Subject: Response to Graves Engineering Review Comments

Proposed Automobile Dealership 701 Boston Turnpike, Shrewsbury, MA

Site Plan Review

Photo 1: Catch basin at the proposed South Street driveway entrance.

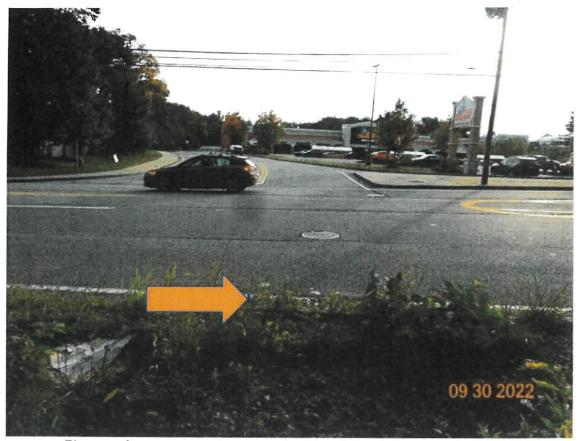
24. Sheet 1 of the Existing Conditions Plans shows a catch basin in the South Street travel lane at the proposed driveway. However, the catch basin is located along the curb line. (See Photo 1 at the end of this letter). The plans propose a connection from the site to the South Street drainage system. The proposed connection will have to be modified to avoid a conflict with the catch basin and the catch basin's inlet grate and curb inlet will have to modified to accommodate driveway traffic. Whereas the curb inlet stone will have to be removed, GEI recommends that the plans include a gutter inlet (to replace the curb inlet's hydraulic capacity) along the South Street curb line up-gradient of the new driveway and that the curb inlet be connected to the existing catch basin for sediment storage.

TLAI Response: Additional survey work was required to locate the catch basin and pipe and to add them to the plan. The catch basin will remain in place, and the header will be removed. We have added a MASSDOT type gutter inlet as suggested by Mr. Walsh. Two proposed catch basins in the two legs of the modified site driveway will also provide additional collection capacity in this area. The sanitary sewer manhole at the intersection was found to be on the east side of South Street in the raised island, it was located by the surveyor, and added to the plan. We reviewed and revised the connections at South Street. See the revised plan and the Serwer Pipe and Invert Table on Sheet C6.6.

TLAI Response: The catch basin was located by field survey and added to the existing conditions plans by Control Point.

The sanitary sewer manhole is visible in this photo in the triangular raised island across the street.
